Product Change Notification

Change Notification #: 111807 - 00
Change Title: RMM4 & Input/Output Module Carrier Board Kits AXXRMM4IOM and AXXRMM4IOMW
PCN 111807-00, Product Design Bracket Change
Date of Publication: October 19, 2012

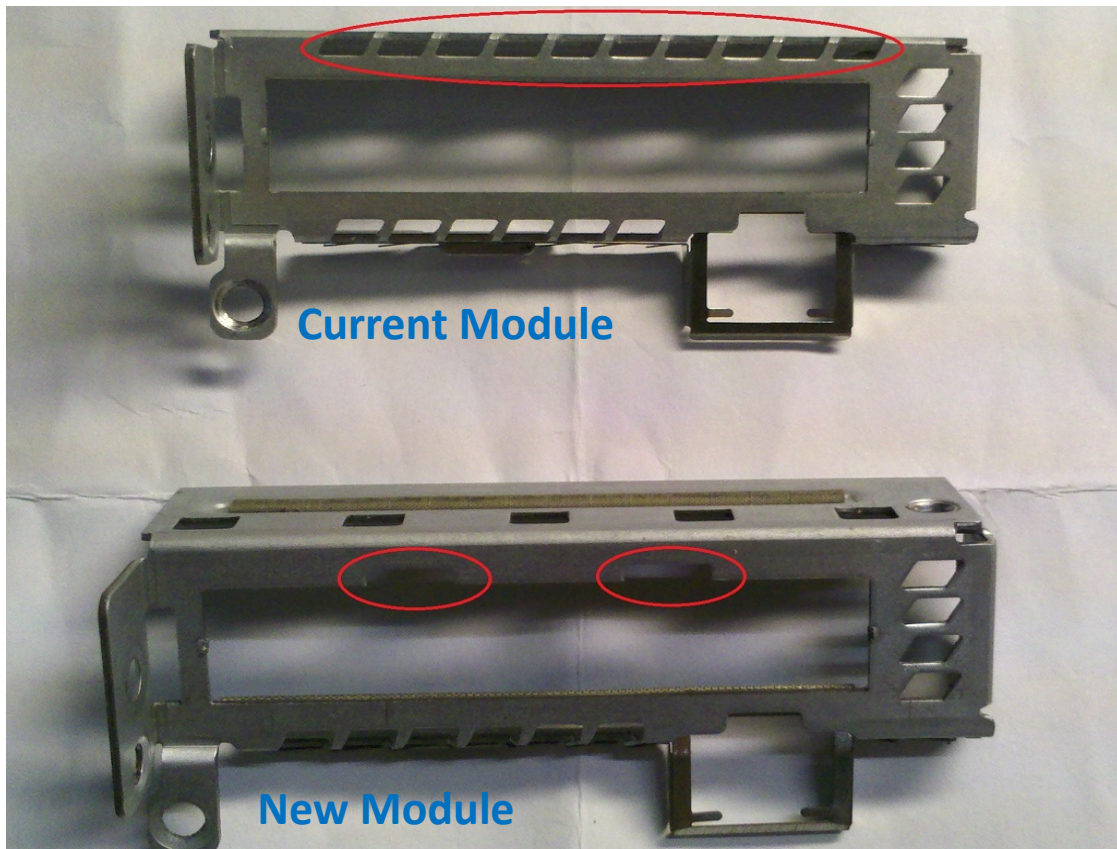
The bracket is being changed to support AXX10GBTWLHW (MM# 924136). The post change bracket supports Ethernet cable RJ45 connector latch fully locked in the RJ45 port in AXX10GBTWLHW. See below pictures for Current and New Module.
